# Final Reclamation Inspection

Operator: CHESAPEAKE OPERATING LLC- 16660

API: 05-123-34627

Inspection Photos  
Location Name: HEIBY 18-8-66 #1H  
API: 05-123-34627

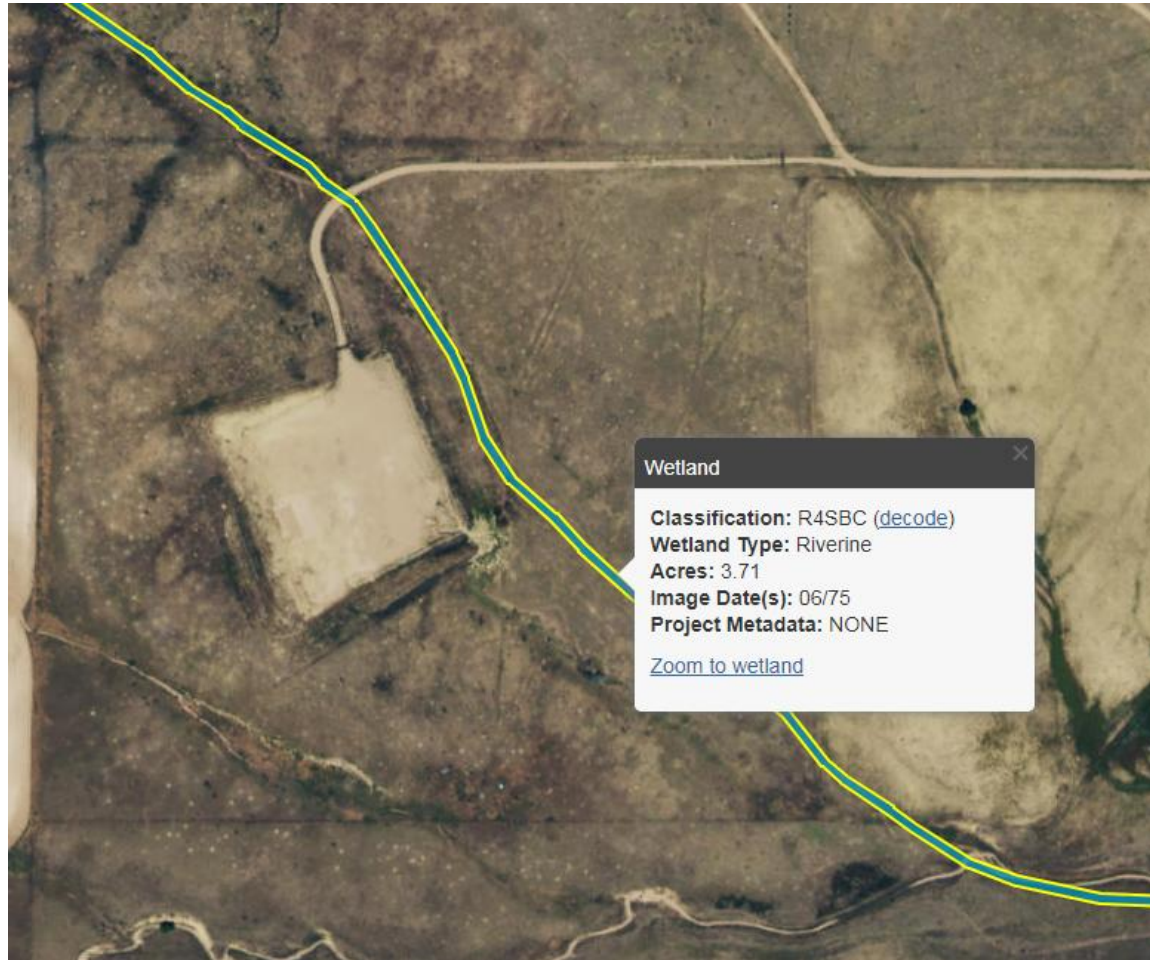
Google Earth imagery taken September 7, 2016 illustrating the ~0.26 mile access road and location (~4.9 acres in size) that have not been reclaimed. Well was plugged July 2, 2014. Refer to the following National Wetlands Inventory aerial imagery illustrating the intermittent stream in relation to the location.
